**Ladder Diagrams for Error  
Recovery For FCP -2 Rev 04  
Out-Of-Order Delivery- Annex D**

**Carl Zeitler**

**Compaq Computer Corporation**

**T10/00-137**

# D.13 REC or REC Response Lost

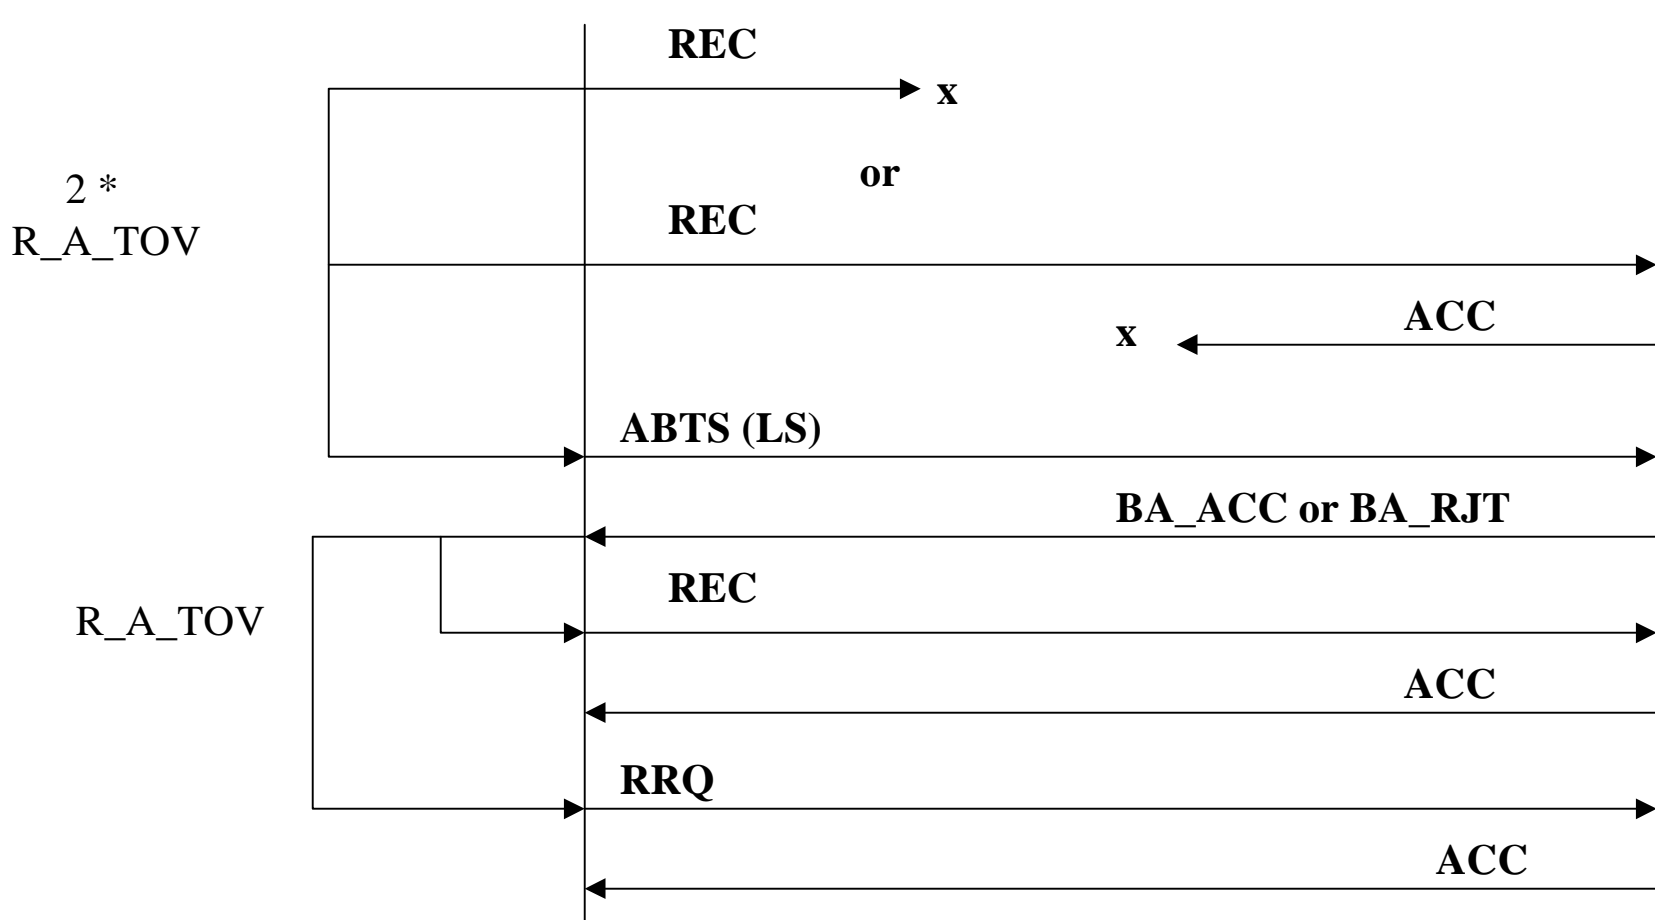
Change E\_D\_TOV in the text to  $2 * R\_A\_Tov$  to agree with the text in 12.6.2

# D.14 SRR or SRR Response Lost

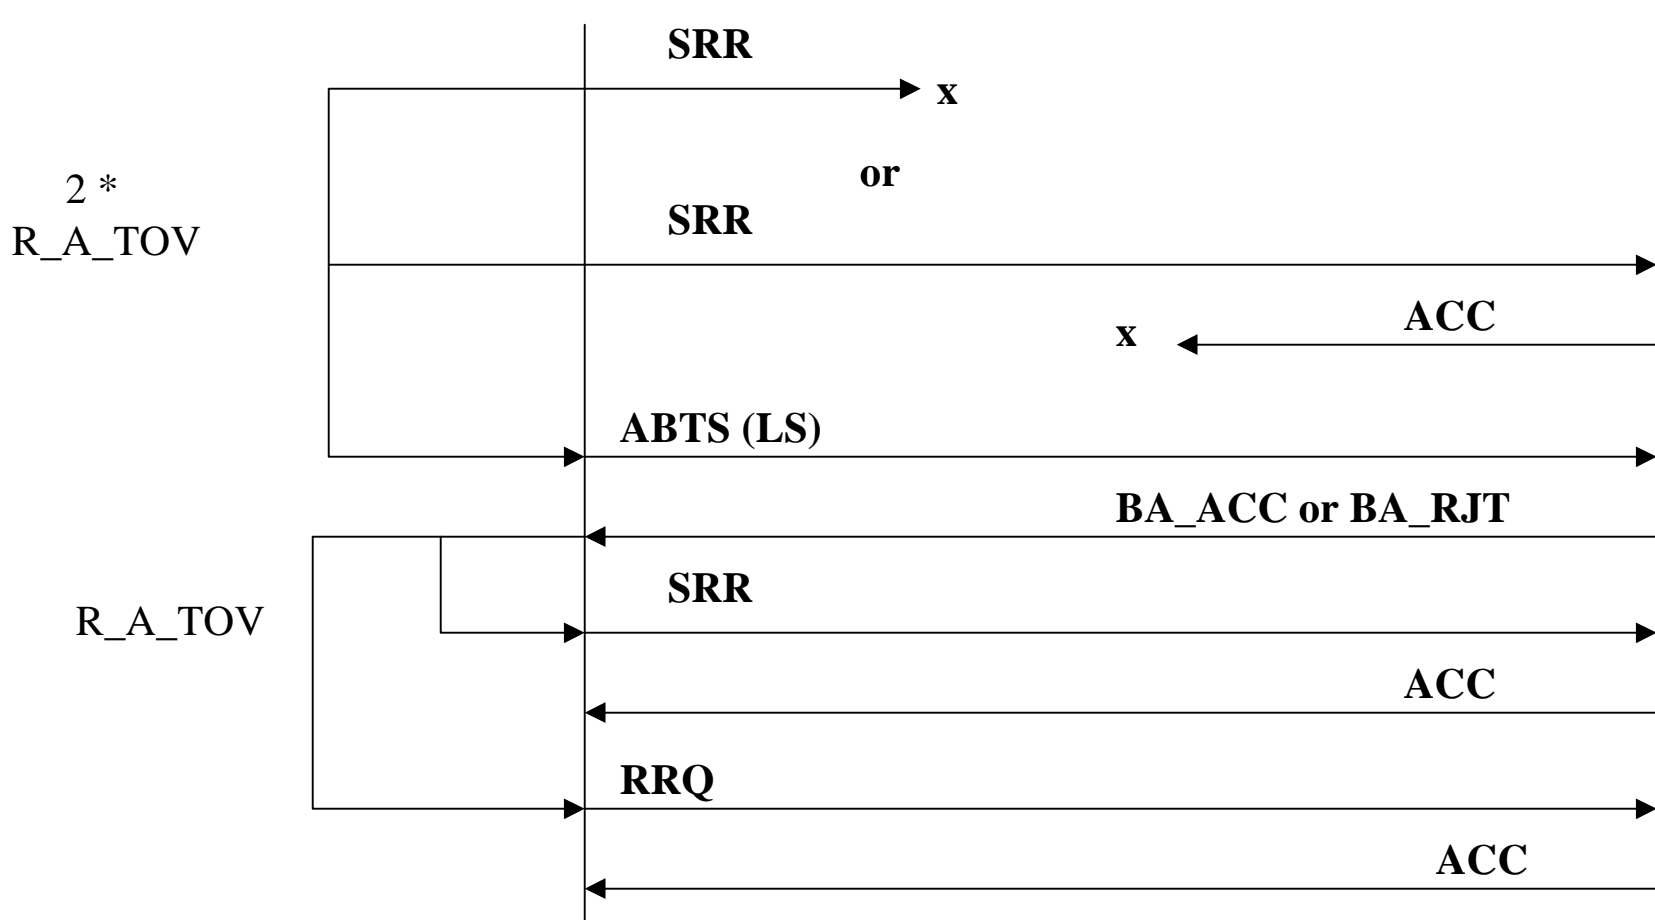
Change E\_D\_TOV in the text to  $2 * R\_A\_Tov$  to agree with the text in 12.6.3
